145.2.8.5.1 PSE ~~PI~~ pair-to-pair effective resistance and current unbalance

145.3.8.10 PD pair-to-pair current unbalance

Annex 145A

Figure 145–22 — PSE current unbalance verification circuit

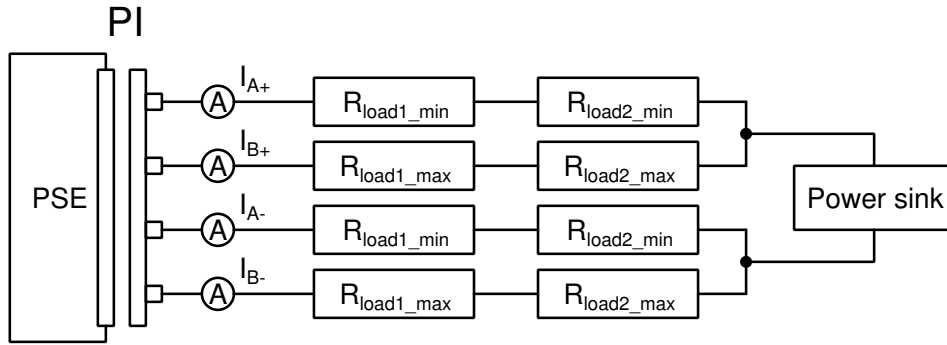
Figure 145–22 is a test fixture that is used in the PSE unbalance requirement. Because it was originally drawn for an Annex, it is too elaborate and shows parameters beyond the PI. It also contains a PD model, which is non-relevant for the PSE unbalance specification.

The equivalent Figure on the PD side is much better (Figure 145–31). Figure 145–22 is redrawn in the style of 145–31 and the PD specific details are abstracted away. The PD specification uses R_{source_min} and R_{source_max} as the test fixture parameters, for the PSE side we introduce R_{load1} and R_{load2} .

Replace Figure 145–22 as follows:

The power sink is set such that the power consumed by the power sink plus the power consumed by the R_{load2} resistances is equal to P_{Class_PD} .

Figure 145–31 — PD current unbalance verification circuit

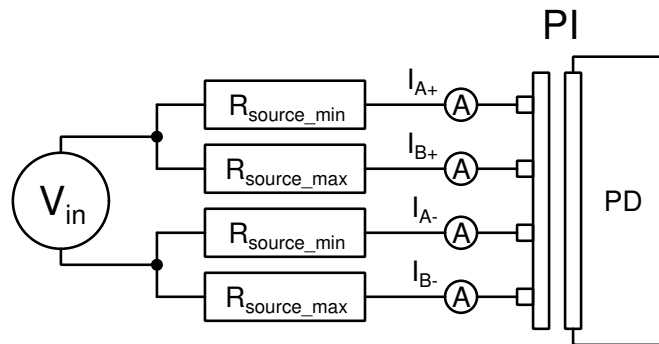
Replace Figure 145–31 as follows:

Figure 145A-0a — PD current unbalance verification circuit

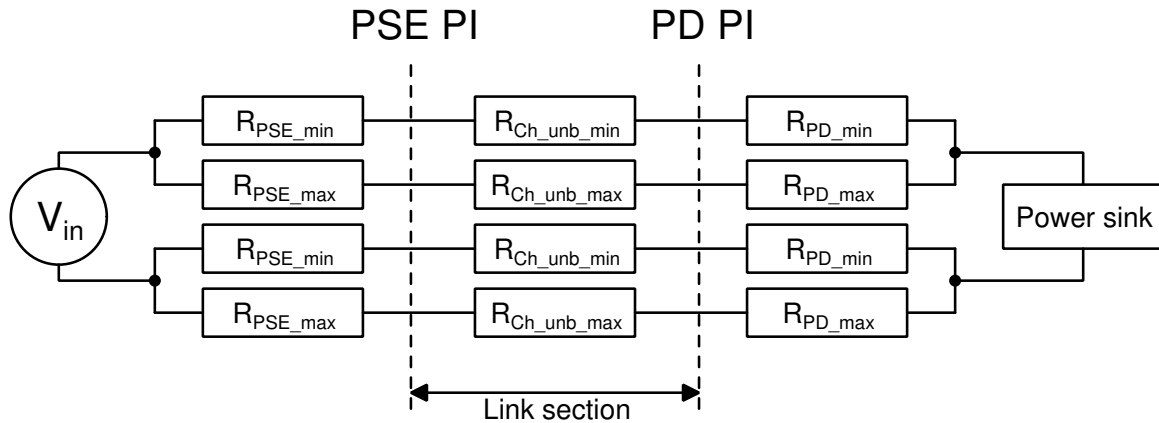
We still need a Figure that shows R_{PSE_min} and R_{PSE_max} as these parameters are referred to in the text. We can replace Figure 145A–1 with something that shows all.

Pair-to-pair current unbalance is caused by unequal resistances in a parallel current path. The PSE, the PD, and the link section connecting those independently contribute to unbalance. A system model is shown in Figure 145A–0a.

R_{PSE_min} or R_{PSE_max} common mode effective resistance is the resistance of the two internal conductors (including the internal components on each conductor) in a powered pair of the same polarity connected in parallel.

$R_{Ch_unb_min}$ and $R_{Ch_unb_max}$ are respectively the minimum and maximum common mode link section resistances in the powered pairs of the same polarity from the PSE PI to the PD PI per the model described in Figure 145A–1.

R_{PD_min} and R_{PD_max} are respectively the minimum and maximum common mode effective PD PI resistances. They account for the effective resistance of the resistive elements, combined with the PD pair-to-pair voltage difference and the effect of system end-to-end pair-to-pair unbalance.
